TOWN OF WATERBURY EXHIBIT **A1**

ZONING PERMIT APPLICATION

Brief description of project: Revisions to the previously approved 9-lot PUD approved under 082-20,
including removing Lot 3, revising access to Lot 7, adding a dwelling unit
on Lot 2, and miscellaneous property line/acreage changes.

<p>REVISION 12/12/2020 REVISED LAYOUT</p>	
<p>OVERVIEW HONEYSUCKLE HILL NINE LOT SUBDIVISION JOHN MUTCHLER & PERRIN WILLIAMS</p>	
<p>SWEET & RIPLEY ROADS WATERBURY, VT</p>	
<p>SCALE : 1" = 200' DESIGNED BY: GNM PROJECT #25130D DRAWN BY: WDB CHECKED BY: GNM</p>	<p>MCCAIN CONSULTING, INC. 93 SOUTH MAIN STREET WATERBURY, VERMONT 05676</p>
<p>DATE: JULY 22, 2020</p>	<p>SHEET C-1</p>

EXISTING PERMITTED VS PROPOSED
HONEYSUCKLE HILL
NINE LOT SUBDIVISION
JOHN MUTCHLER & PERRIN WILLIAMS
SWEET & RIPLEY ROADS WATERBURY, VT

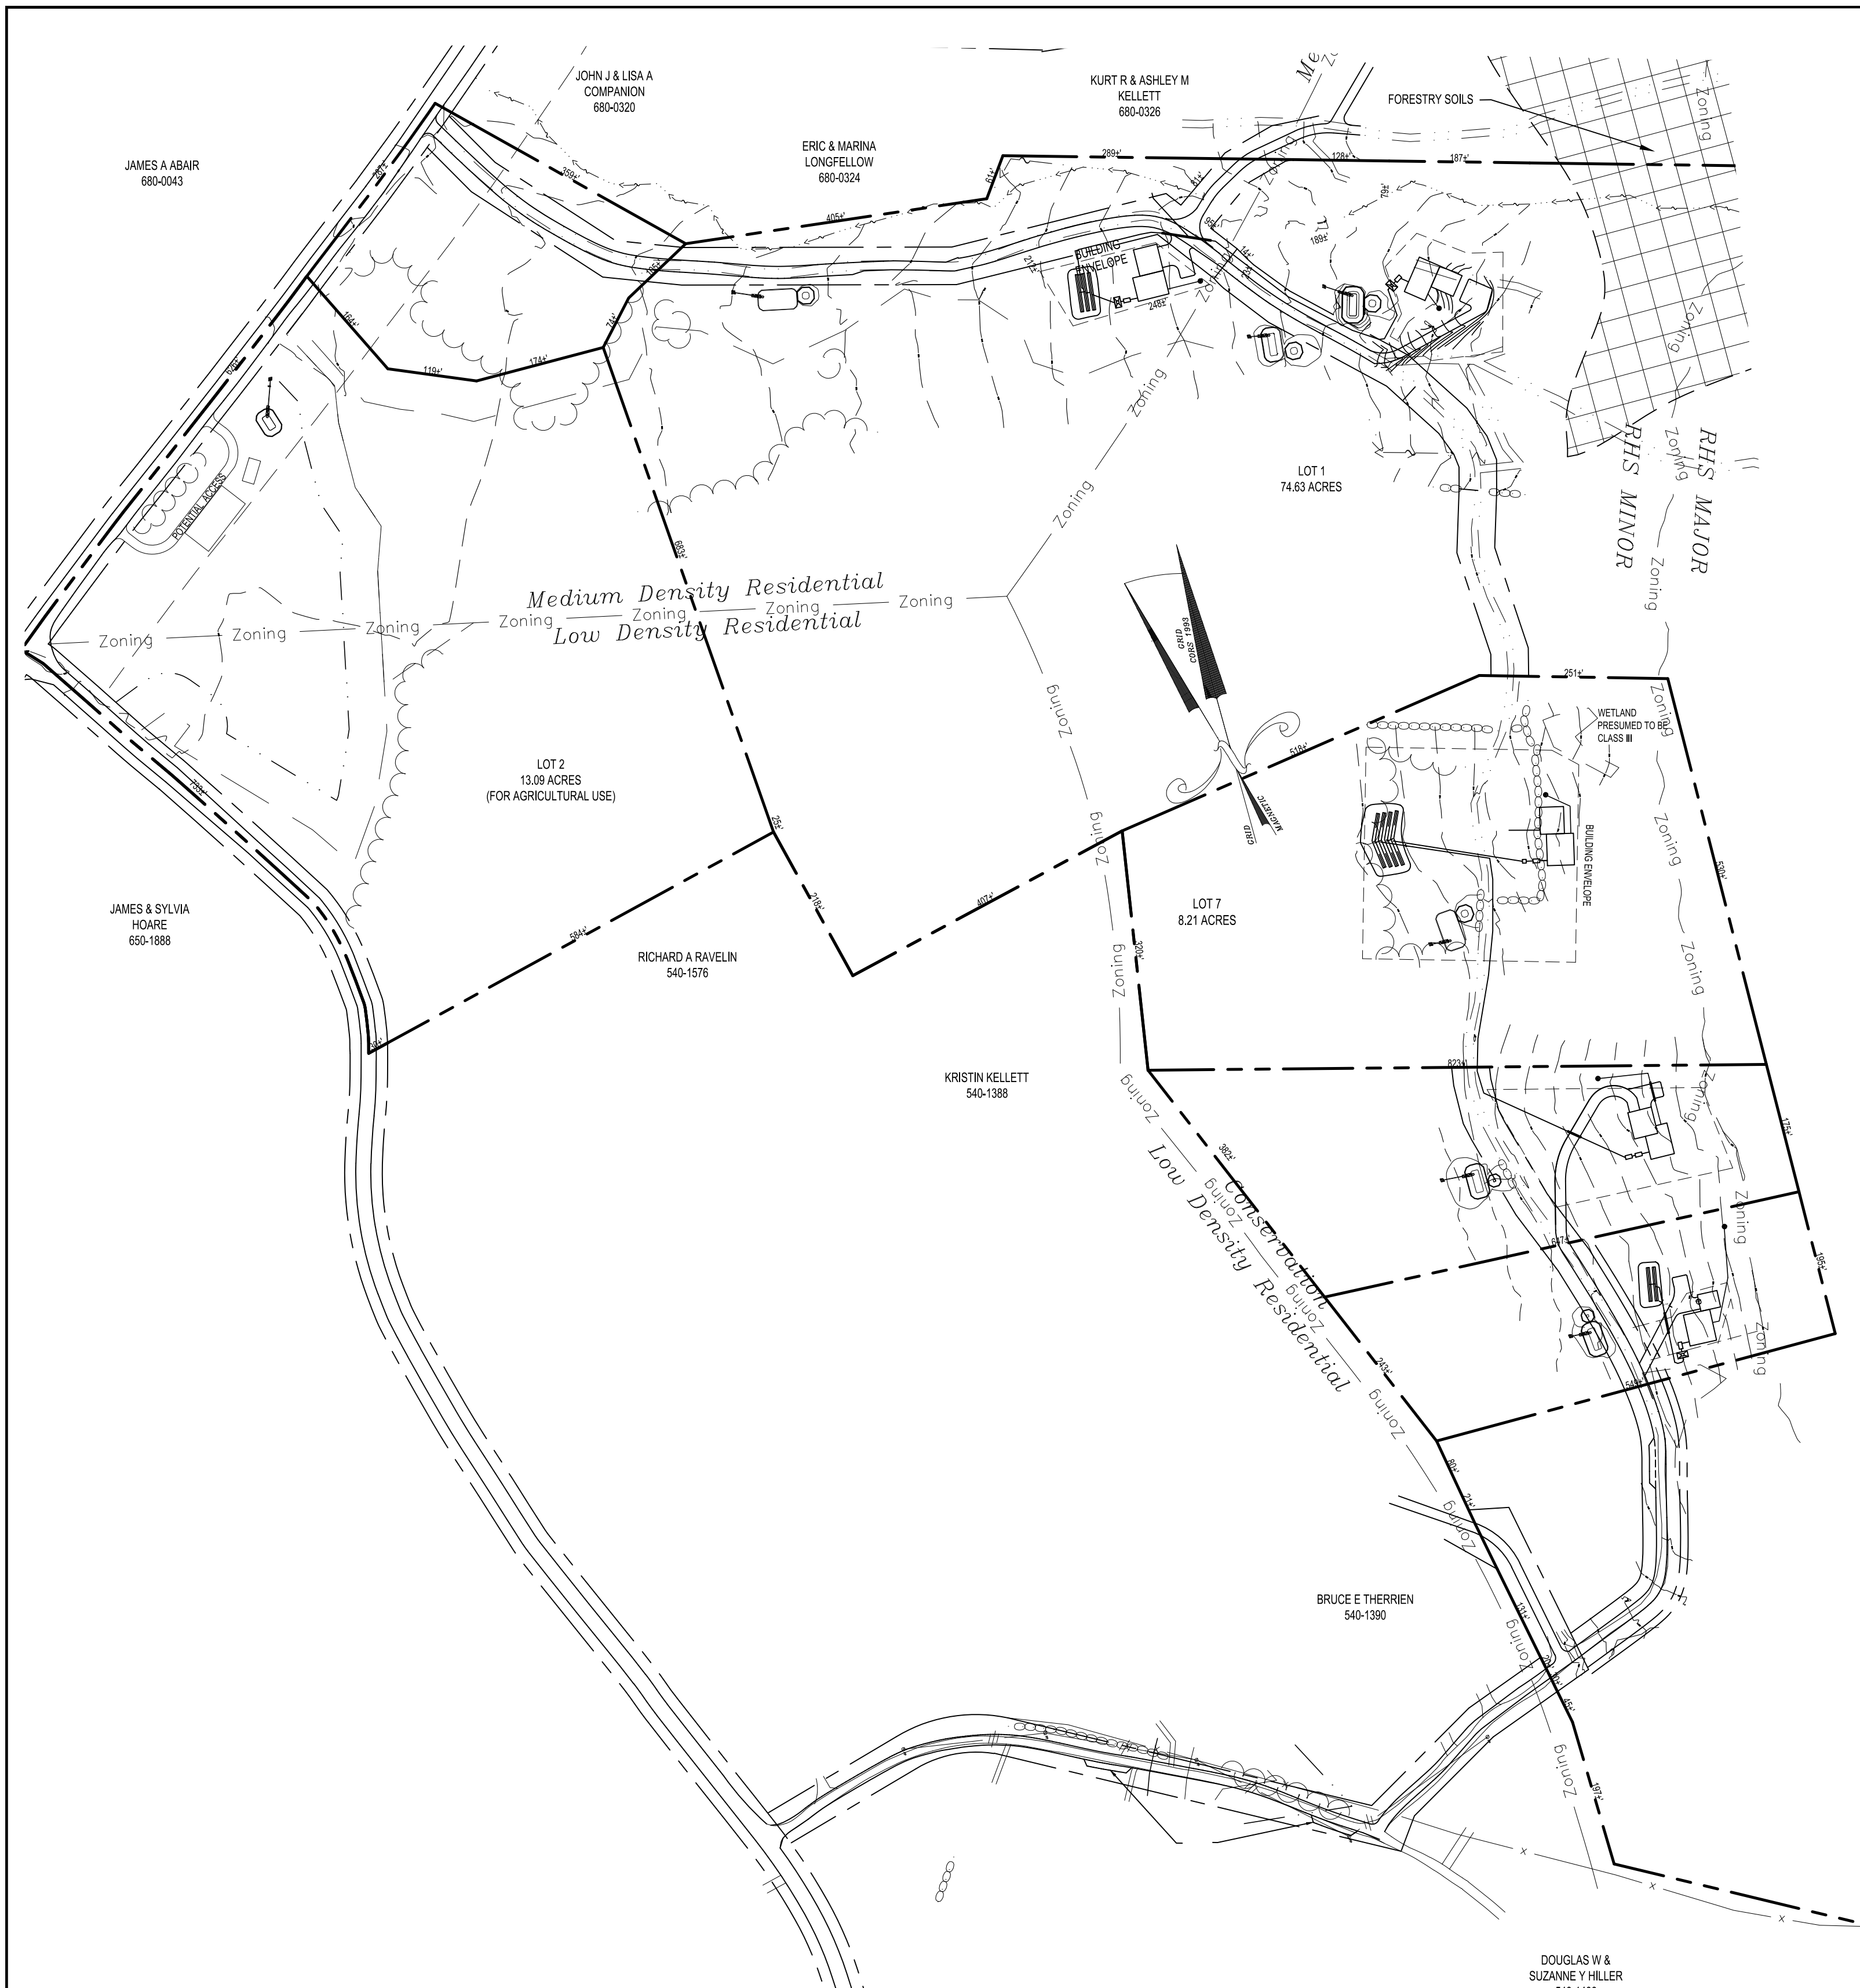
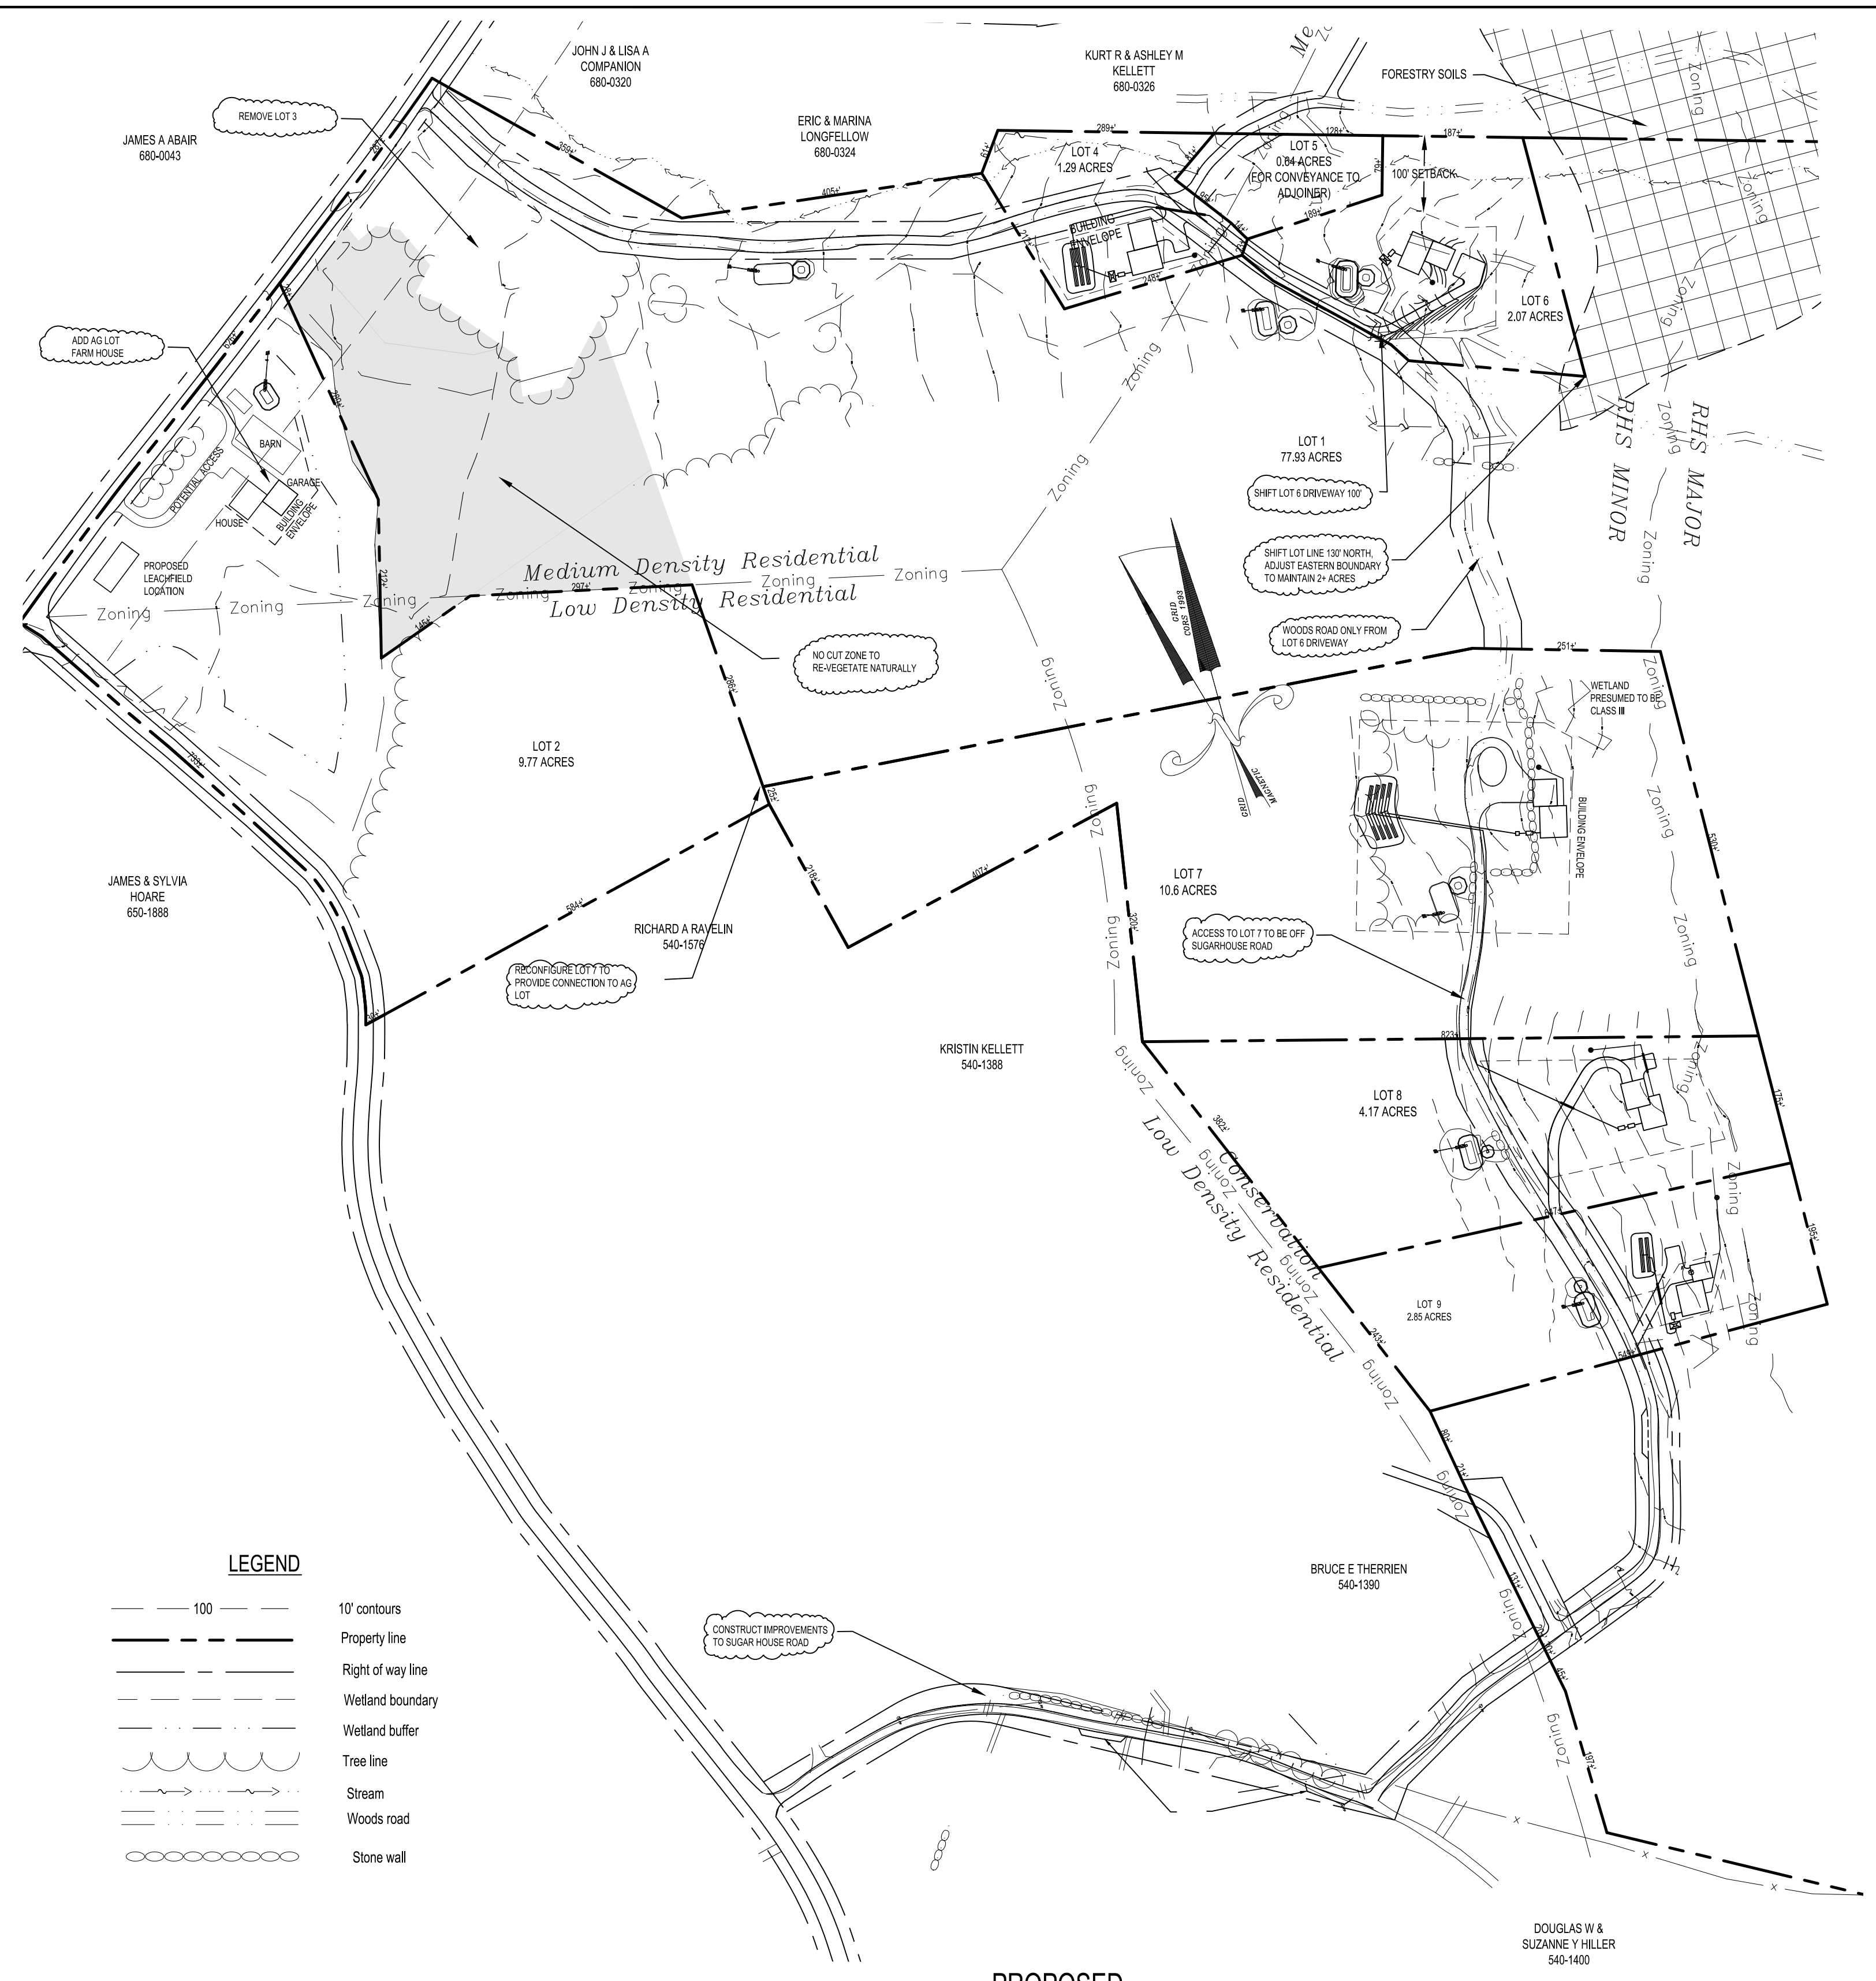
This application is for revisions to the previously approved PUD due to comments that arose during the Act 250 review process. The attached project narrative describes the changes and rationale in more detail, which include: removing Lot 3 in its entirety to preserve the wooded area that was identified as a “Rare and Irreplaceable Natural Area” and adding a re-vegetated area on Lot 2 to supplement it; revising the access to Lot 7 off of Ripley Road/Sugarhouse Hill Road to improve wildlife movement opportunities; adding a dwelling on Lot 2 that was previously proposed for agricultural use, and; miscellaneous property line/acreage revisions to

AS PERMITTED

PROPOSED
